LAA/AWA/19/24
Superseding LAA/AWA/19/19
16th December 2019

Rotax 915i A & Rotax 912i (Series) Aircraft Engines Replacement of Fuel Pump Assembly

Pump Assembly Serial Numbers Affected.

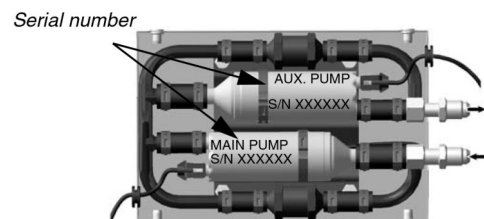
BRP Rotax have re-issued (for the second time) an Alert Service Bulletin (ASB) affecting aircraft fitted with the Rotax 915iA and Rotax 912i (Series) engine. The issue affects Rotax fuel pump assemblies with serial numbers which fall between a range specified in the ASB.

This revision now provides 2 options for full compliance should the fuel pump assembly fall within the affected range. Option 1: An affected assembly may be replaced with a new assembly or, option 2, compliance can be achieved by replacing the individual pumps within the assembly.

Fuel pump assy.	Description	Serial number
Part no. 889697	Fuel pump assy. UNF packaged (889696 + 3x 850620 + packaging)	from S/N 180500 up to S/N 192699 inclusive
Part no. 889699	Fuel pump assy. METRIC packaged (889698 + 3x 850620 + packaging)	from S/N 180500 up to S/N 192699 inclusive
